CONNECTICUT SITING COUNCIL

RE: **PETITION NO. 1352** – Nutmeg Solar, LLC, declaratory ruling, pursuant to Connecticut General Statutes §4-176 and §16-50k, for the proposed construction, maintenance and operation of a 19.6-megawatt AC solar photovoltaic electric generating facility on approximately 162 acres comprised of 9 separate parcels located generally south of Bailey Road and east of Route 191 (Broad Brook Road), and associated electrical interconnection to Eversource Energy's Scitico Substation at 20 Bailey Road in Enfield, Connecticut.

Petition No. 1352
Nutmeg Solar, LLC
Development & Management Plan
Enfield
Staff Report
January 16, 2020

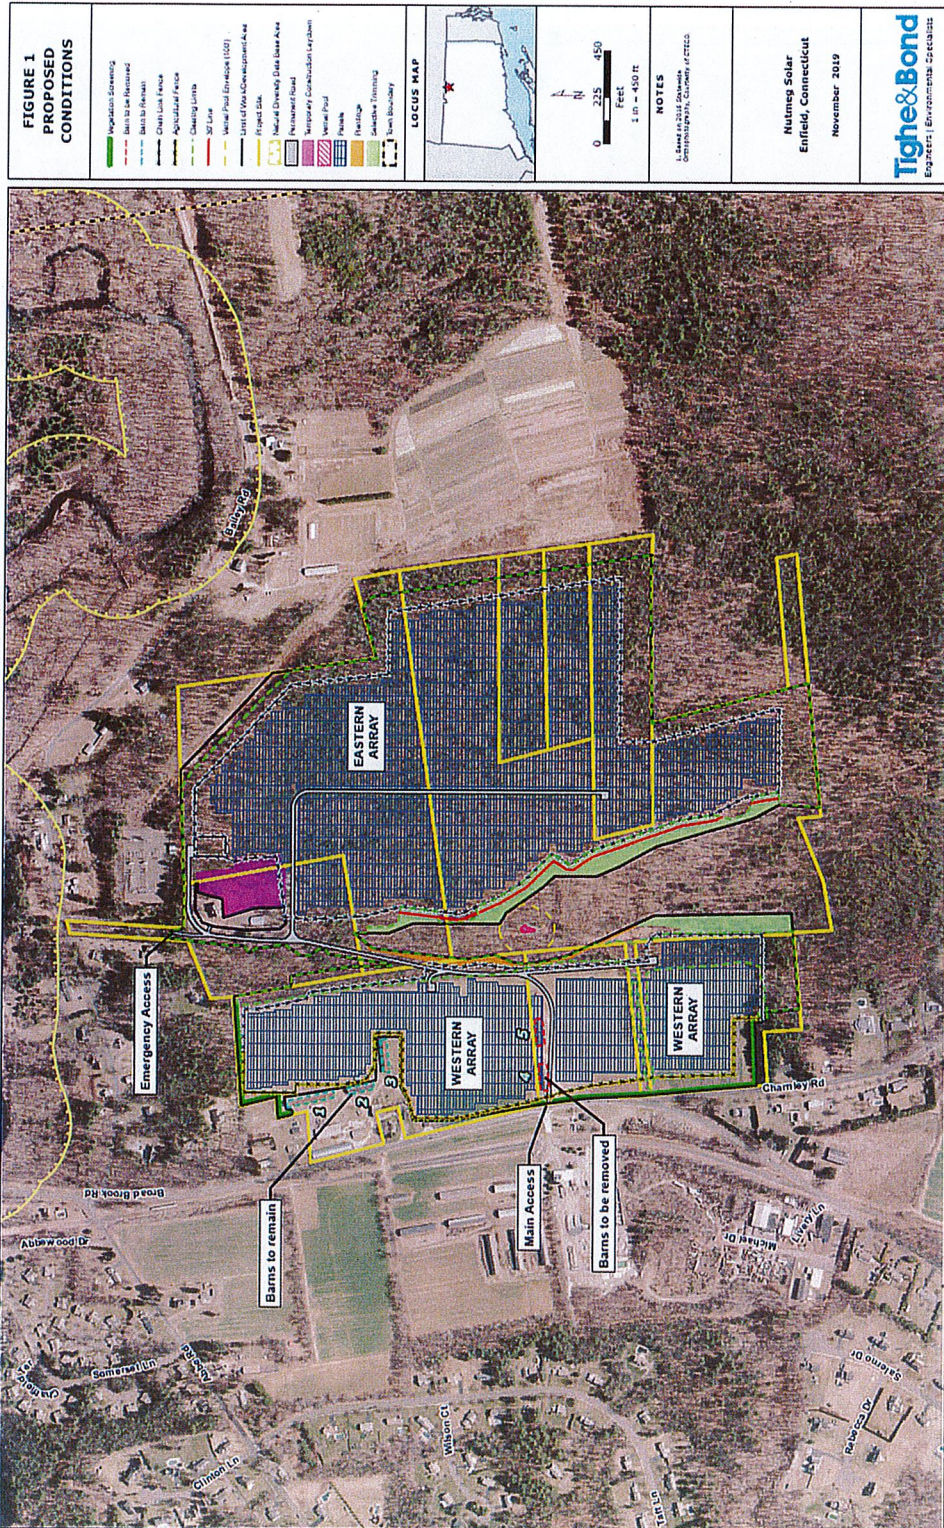
Tobacco Barn Nos. 1, 2 and 3 are currently located in the northwestern portion of the site off of Broad Brook Road. In the originally approved configuration, Nutmeg planned to demolish/remove Tobacco Barn No. 3 and relocate Tobacco Barn Nos. 1 and 2 to the northwestern limits of the project area to serve as a visual barrier. Tobacco Barn Nos. 4 and 5, located in the western-central portion of the site, were slated to be removed. See attached figure titled "Originally Approved Configuration."

Upon further consultation with the landowner, and as a result of consultations with SHPO, in the D&M Plan, Tobacco Barn Nos. 1, 2 and 3 will remain in place in their current locations. Nutmeg has professionally documented the historic and architectural aspects of Tobacco Barn Nos. 2 and 3 and submitted the information to SHPO as requested. By letter dated April 22, 2019, SHPO confirmed receipt of the documentation. Also in the D&M Plan, Tobacco Barn Nos. 4 and 5 will still be removed as originally proposed.

The solar panel layouts have been adjusted to accommodate all of the changes. Furthermore, the landscape plantings in the northwestern limits of the site have been extended to the east to compensate for loss of visual screening that would have been provided by a relocated Tobacco Barn No. 2. Landscape plantings will remain in the vicinity of where Tobacco Barn No. 1 would have been relocated. See attached figure titled "Revised Configuration."

Selective Vegetation Management

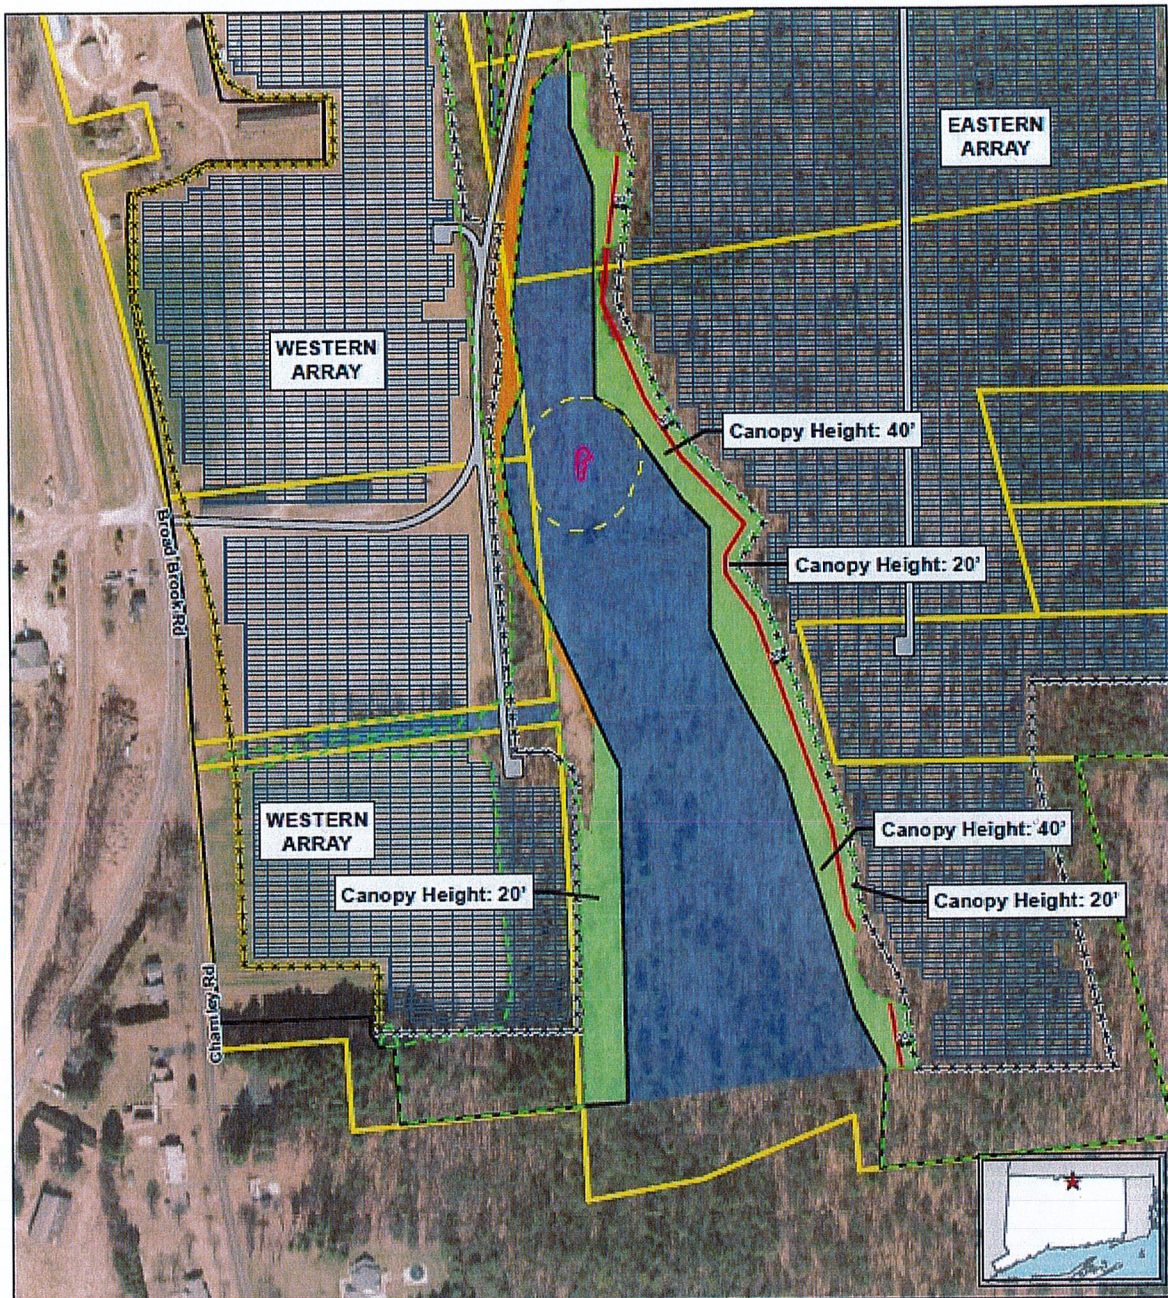
Under Attachment F of the D&M Plan, Nutmeg has included its Selective Vegetation Management Plan (SVMP) for the directional corridor⁶ area in the vicinity of the vernal pool. See attached figure titled "Selective Vegetation Management." Specifically, the SVMP includes, but is not limited to, the following:

- a) No trees will be removed within the 100-foot Vernal Pool Envelope or within the directional buffer that extends south of the pool to the southern boundary of the project;
- b) Trees within the selective trimming area that are within 30 feet of the arrays will be selectively trimmed and maintained to have a canopy height of 20 feet;
- c) Trees within the selective trimming area that are outside of the 30-foot setback will be selectively trimmed and maintained to have a canopy height of 40 feet;
- d) Trees that are cut within the selective trimming area will be cut at the base; and
- e) Following project construction, the selective trimming areas will be reviewed on a five-year cycle, and tree species observed to be capable of exceeding the canopy height within five years will be removed.
